LIVSEY & COMPANY, INC.
INDIANA & MICHIGAN ELECTRIC CO.
DONALD C. COOK NUCLEAR PLANT

CONTAIN. VICINITY
DWG. NO. 2-NSW-111 SH. 2 OF 2
REV. 9

2NSW-111 (sheet 2 of 2)
Upper Containment Ventilation
Unit 1 Supply Line

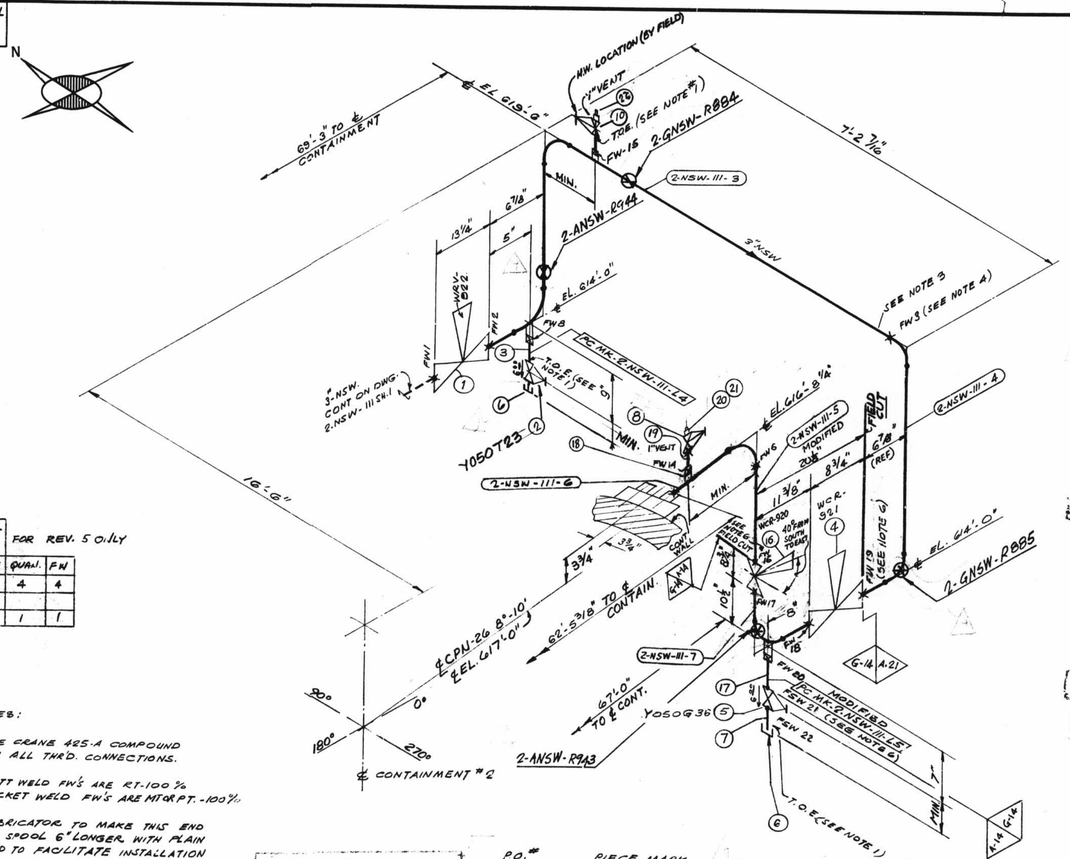
| NO. | DATE | BY CHK | DESCRIPTION | REMARKS |
|---|---|---|---|---|
| 1 | 1-20-76 | DLB B.R. | REVISED BY AEP. DESIGN: PER RFC-DC-12-671: REV'D: ITEM #5 Y-050G36 WAS CY-050G36. ADDED; 3" CHECK VALVE - C15CE03A, 1" VENTS - VALVE NO Y-100T23. Y-100 T-36 | ACTION REQ'D. |
| 2 | 12-30-76 | W.R. | ADDED: PLUG TO DRAIN VALVE, ITEM 11, @ 6'-6 3/4" DIMEN. W.R. | |
| MF 3 | 9/21/78 | G.P. L.B. | AS PER RFC-12-1730 DELETED VALVE TAG NO. C15CE03A, ADDED VALVE TAG NO. C15CW03A & ITEMS 12 THRU 15 AND REUSED RELATED PIPING. | FIELD ACTION REQ'D |
| MF 4 | 9/11/80 | A.G. | PER RFC DC-12-2549 REPLACED 3" CHECK VA. & WCR 921 WITH DIA PH. CONTROL VA'S. WCR-920, 921, ADDED PIPE SPEC. G-14. NOTES 6 & 7, WELD BOX, WELDS FW16 & 22, 25, FSW 23, 24 2-NSW-111-7, ITEMS NO. 16 TO 19 TO B/M DIM'S. | FIELD ACTION REQ'D. |
| MF 5 | 9/28/81 | K.A. DLF | PER RFC DC-12-2549 RELOCATED VALVE WCR-920 ADDED: DIM. PC MK 2-NSW-111-7, REF NOTE, REV. WELD BOX, MODIFIED TO PC MK. 2-NSW-111-5, REINSTATED PC MK 2-NSW-111-5. | FIELD ACTION REQ'D |
| MF 6 | 10/28/81 | J.L. J.H. | PER RFC DC-12-2549 DIM. 7'-2 7/16" WAS 7'-2 3/16" AND ADDED DIM. | NO FIELD ACTION REQ'D |
| MF 7 | 5/4/82 | K.J. J.H. | PER RFC. DC-12-2549 RELOCATED FIRST CONN. | FIELD ACTION REQ'D |
| MF 8 | 6/1/82 | K.E. J.M. | PER RFC DC-12-2549 ADDED RED. INSERT & PLUG TO ITEM 19 & B/M. | |
| MF 9 | 7/12/89 | R.B.B. D.W.M. L.B. | TO REFLECT AS-FOUND CONDITIONS FOR RFC-DC-12-3010 PER FWR # 759 REV. 1, ADDED: 1" PLUG & ITEM NO. 22 ON B/M. REVISED: 1/2" PLUG TO 1/2" CAP & B/M TO SUIT. ADDED: SUPPORT MARK NOS. & SUPERSEDES HGR. 150. # 2-GNSW-III SH. NO. 2. | NO FIELD ACTION REQ'D. |
